**Charter Township of Comstock
Planning Commission Meeting**

**NOTICE AND AGENDA
December 15, 2016 at 7:00 PM
Lower Level of the Township Office**

STAFF REPORT

STAFF REPORT

SITE PLAN

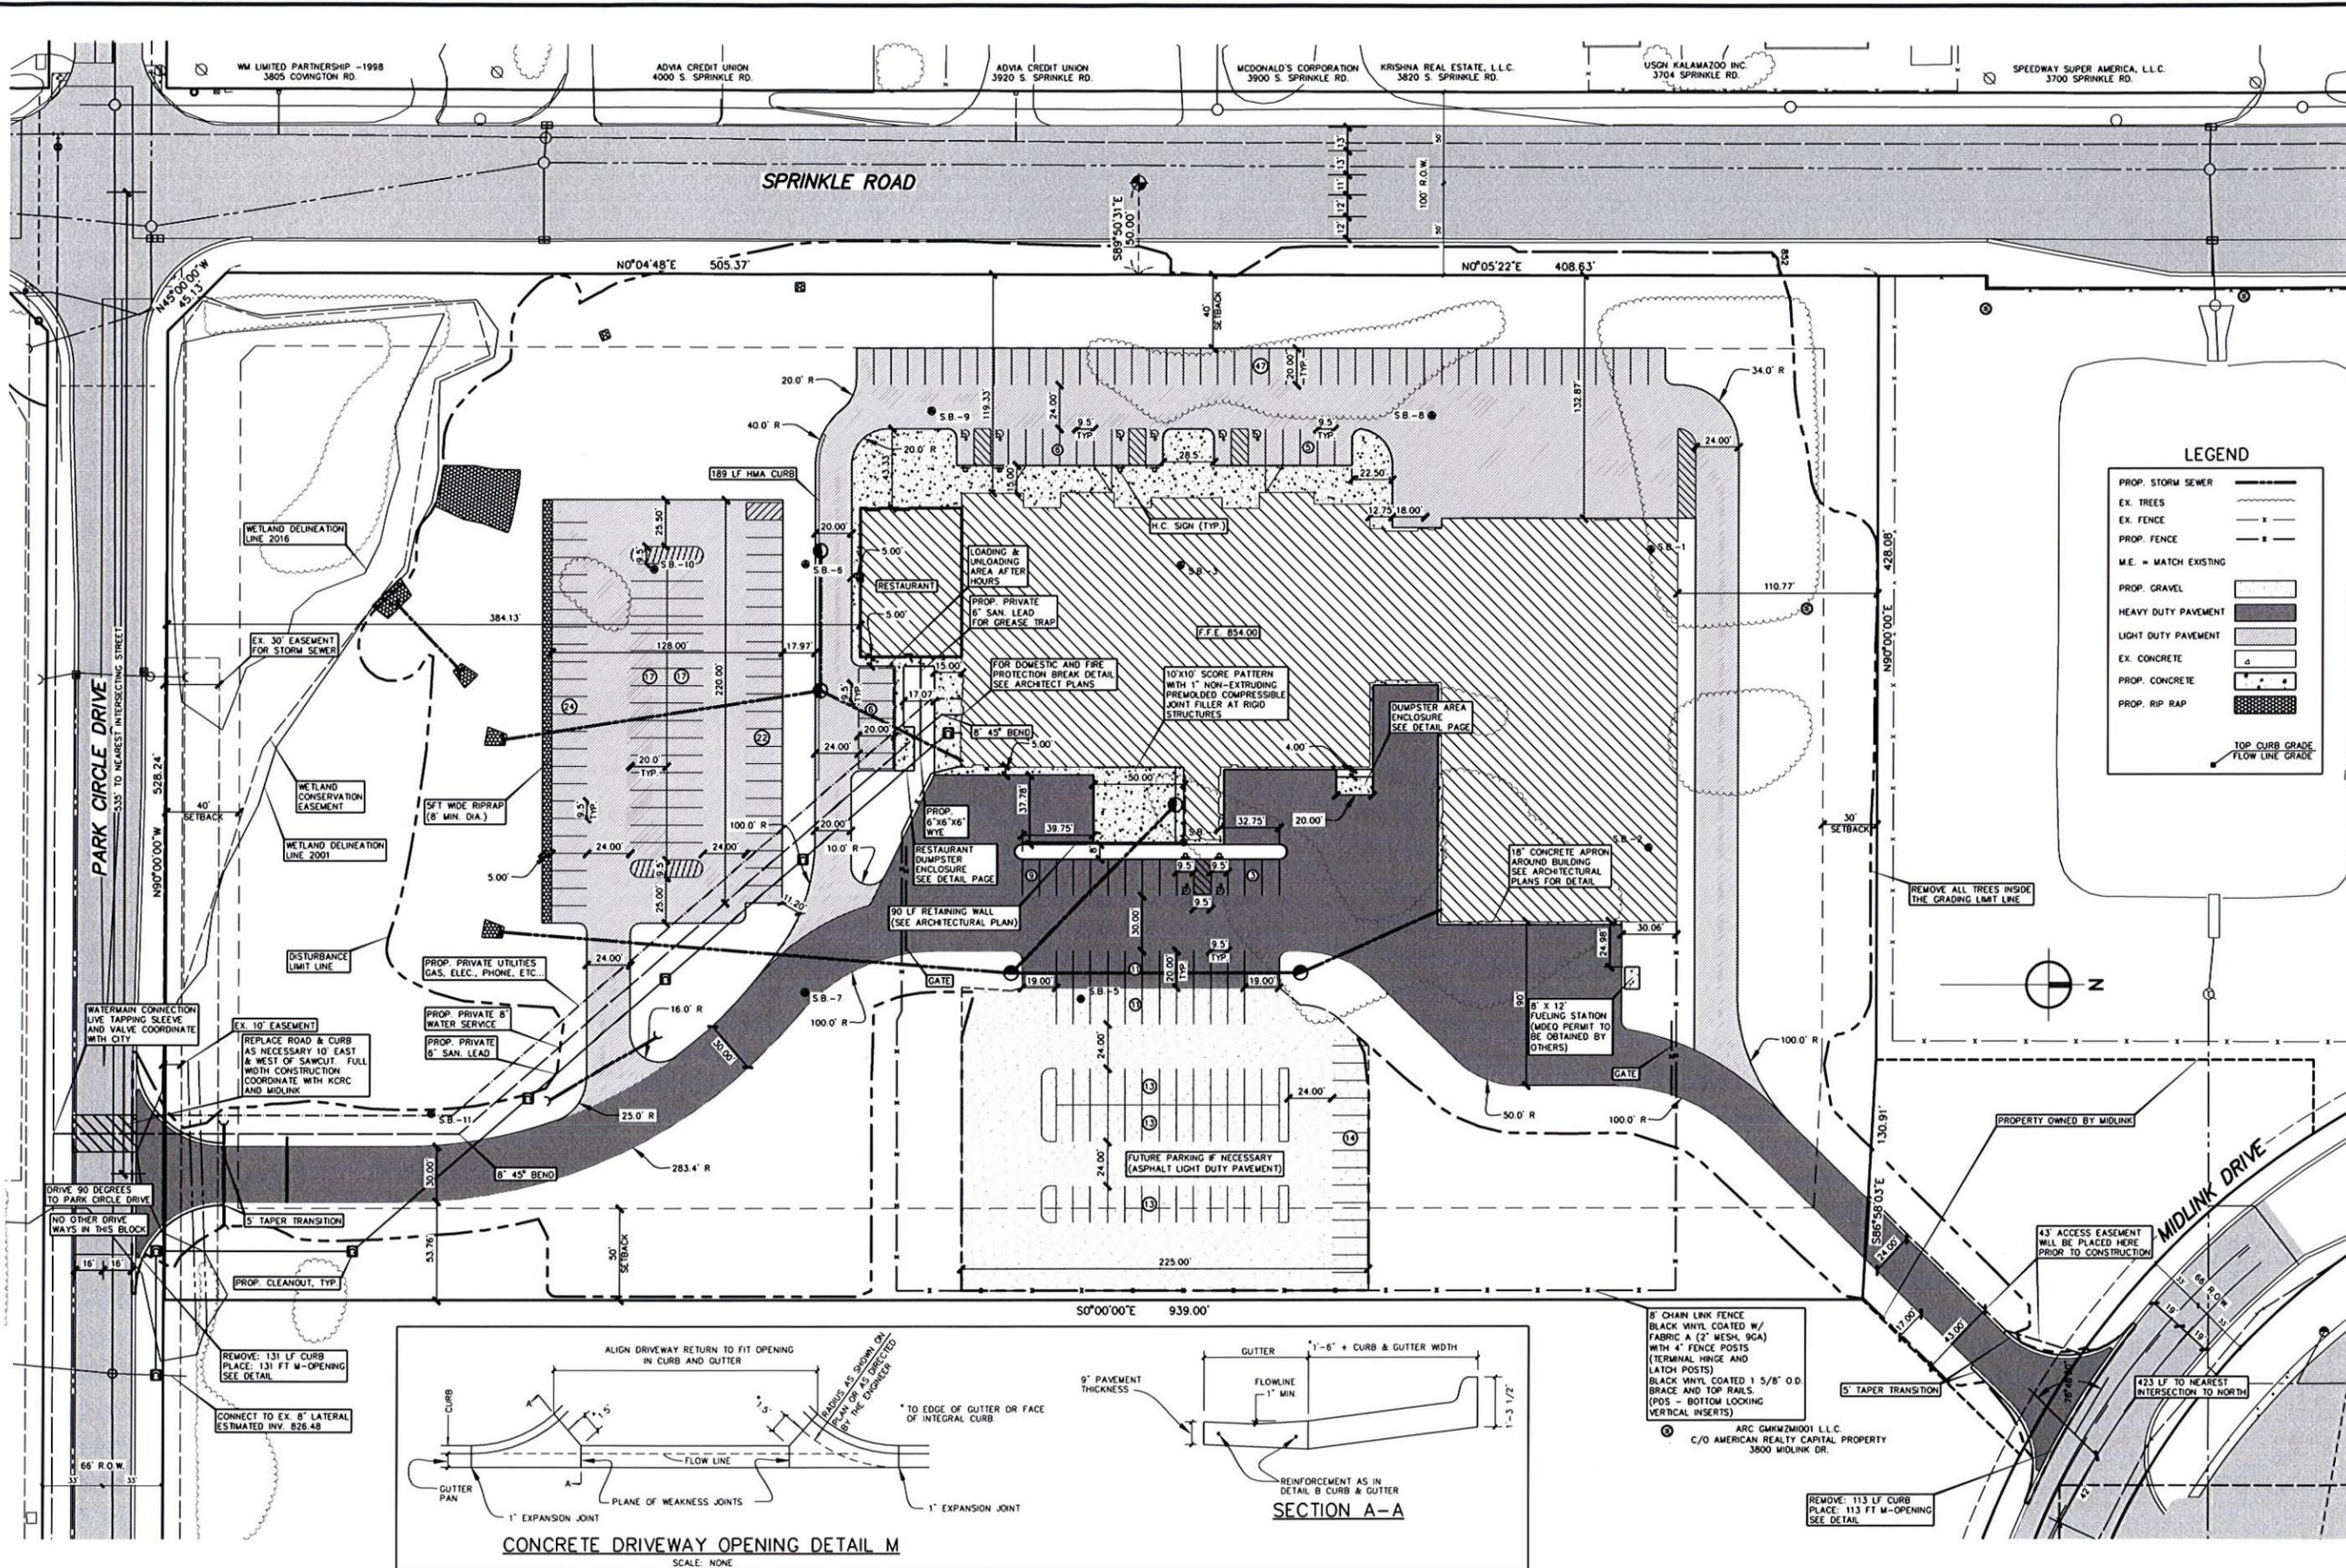
A 4,300 square foot restaurant has been added to the south end of the building. This expansion to the building caused further changes to parking and internal circulation. Previously a 27-space parking area was provided on the south side of the building with a 24-foot wide drive aisle. Now, there are six parking spaces on the south side of the building and a drive aisle ranging from 20

feet (effectively 18 feet) to 24 feet wide. Three of the six parking spaces are in front of the dumpster serving the restaurant. Staff did ask for the dumpster to be relocated to another area of the site but the applicant prefers to keep it where shown on the site plan.

- Dumpster should be moved to another location, perhaps in the green area east of the proposed location with service from the north side (this may require moving the planned fence and gate location to allow servicing the dumpster).

- Concerns noted above about the drive aisle narrowness.
- Possible internal directional signs to keep/minimize vehicles with trailers and trucks from using the south drive along the building.
- Concerns noted above about the dumpster location.
- Landscaping as deemed appropriate during the review and discussion.
- Parking deferment of up to 64 spaces, if found appropriate; the deferred spaces will be constructed when it is determined by the Planning Commission that they are needed, pursuant to Section 6.02(2).

LANDSCAPE PLAN

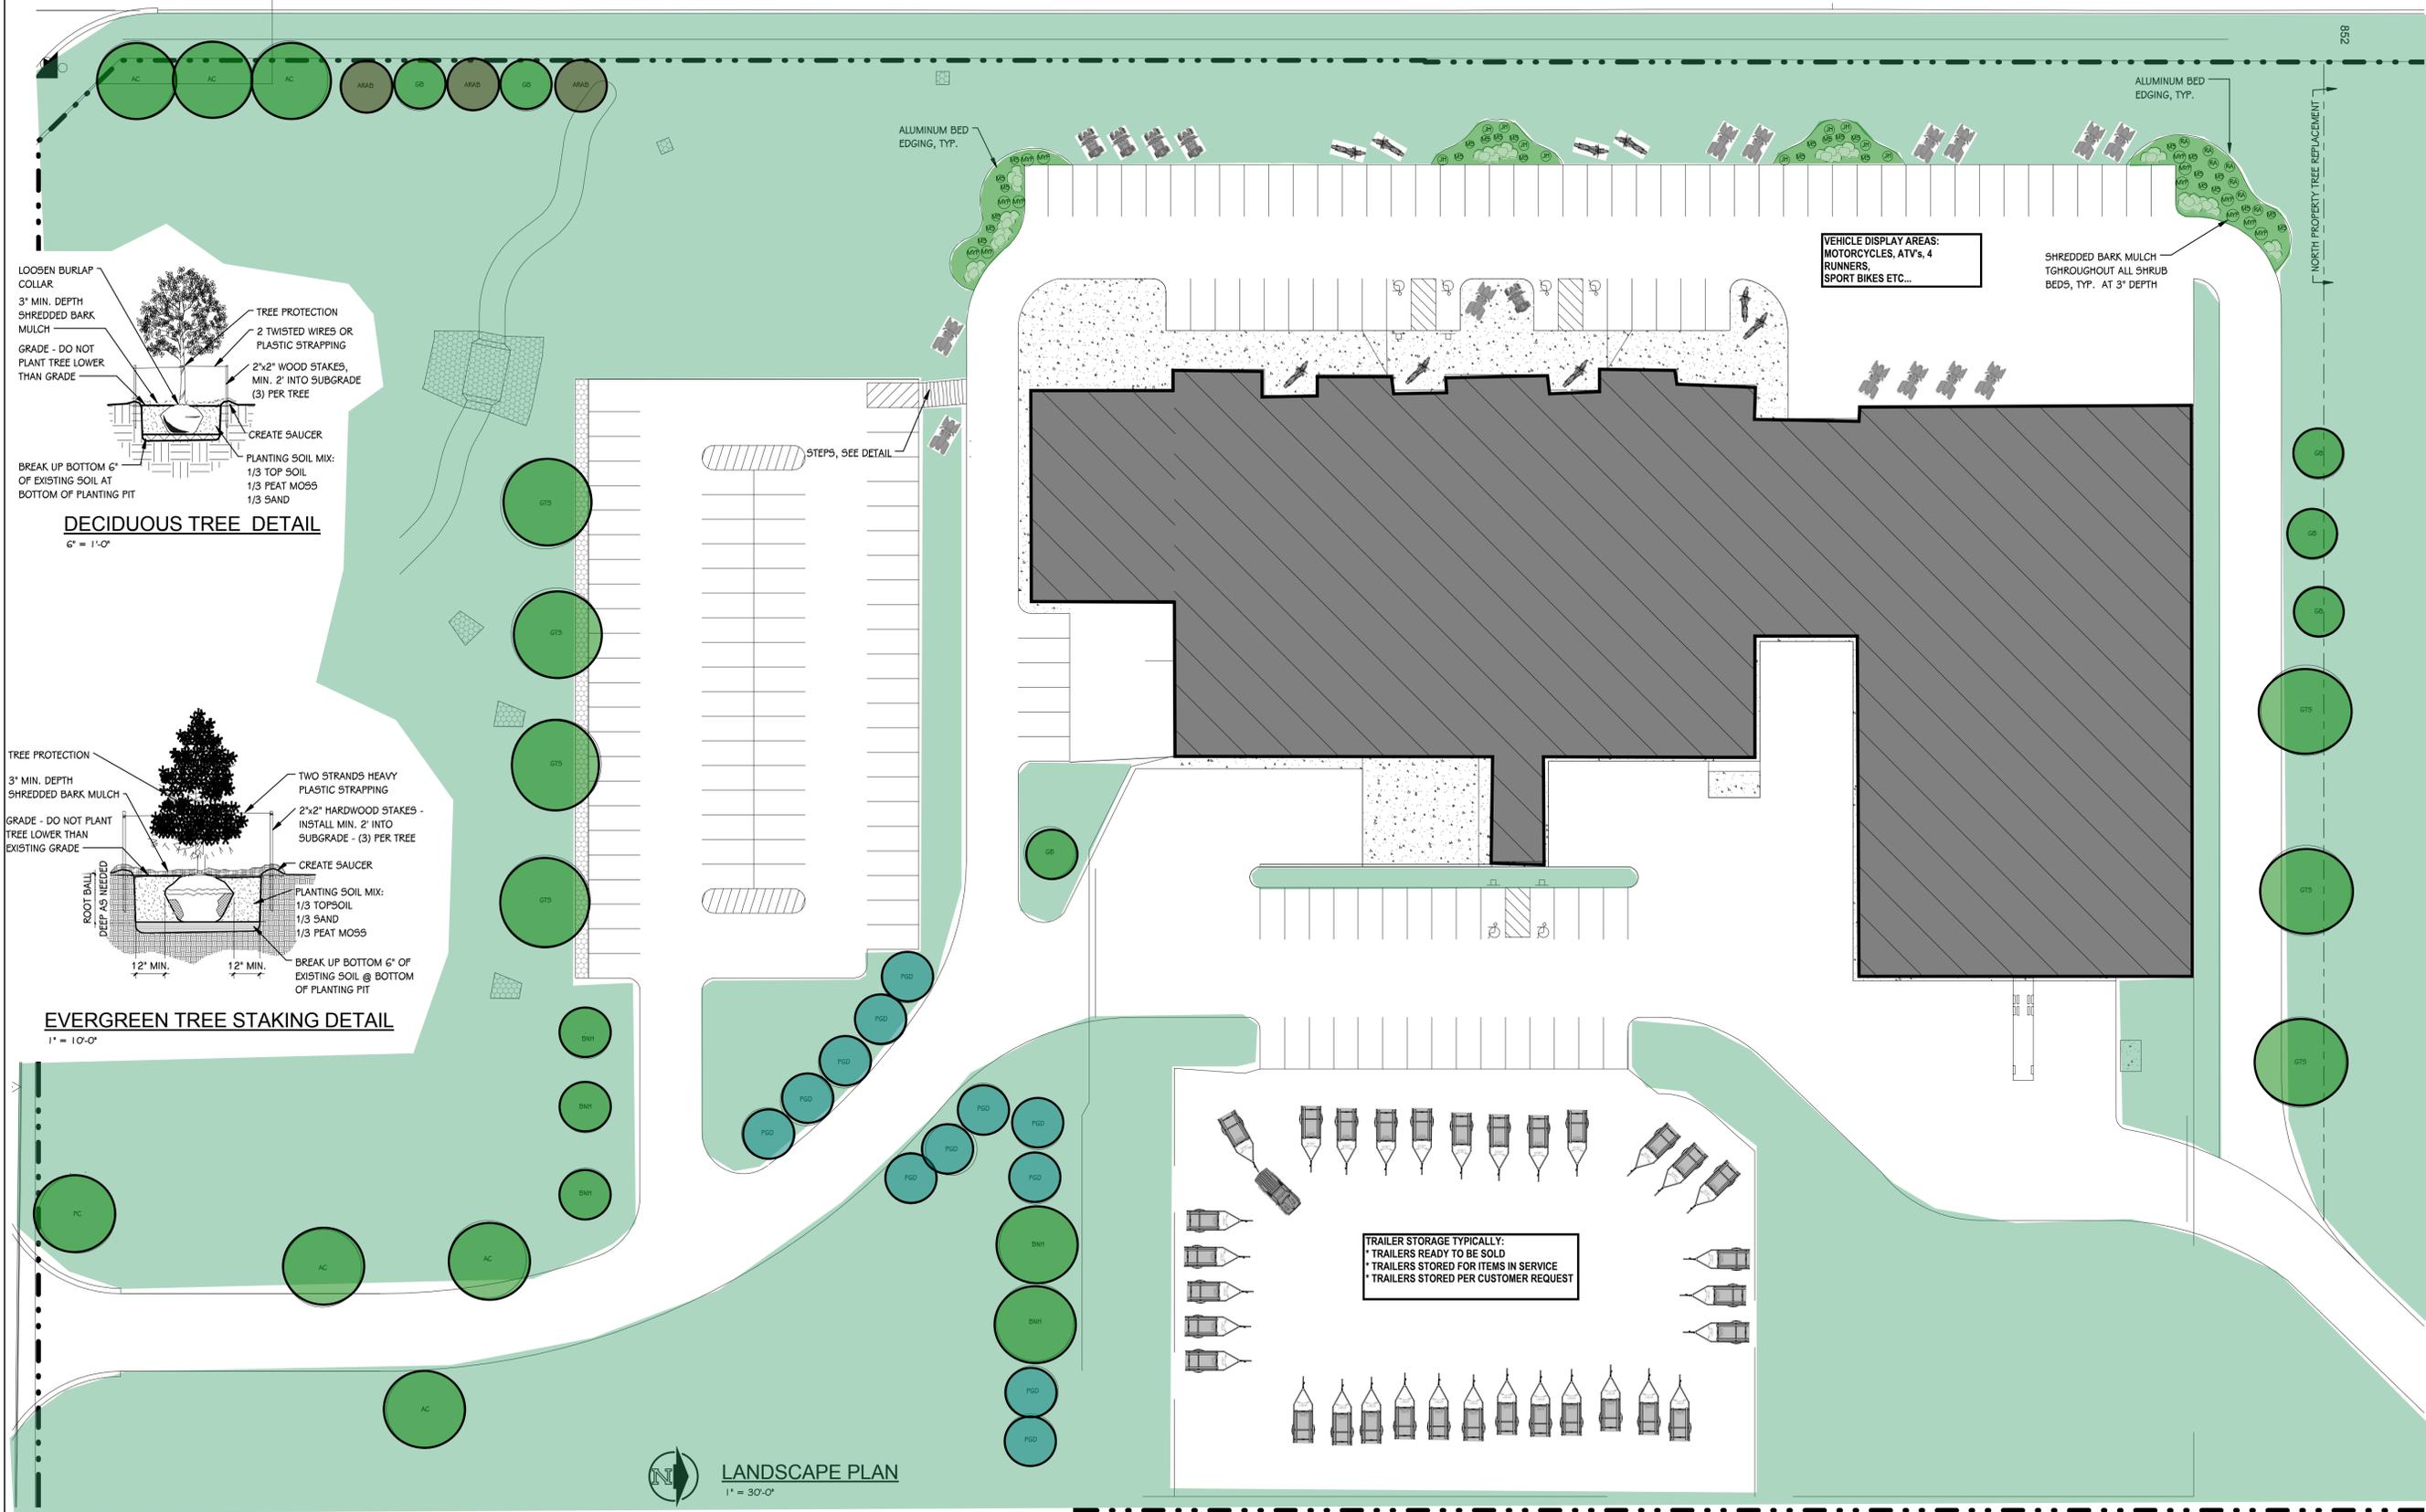
The landscaping plan shows 6 new trees being planted on the berm and the addition of 8 trees along Sprinkle Road in addition to the interior landscaping previously required by Midlink (mix of canopy trees and understory trees totaling 26). Staff would submit that timing is such that this project was well underway before the landscaping ordinance was adopted, including the addition of the restaurant. Consider the applicant's anticipated comments on Thursday as to the preferred landscaping plan (attached) and what would be required along the north property line and Sprinkle Road if site plan approval were just now being requested:
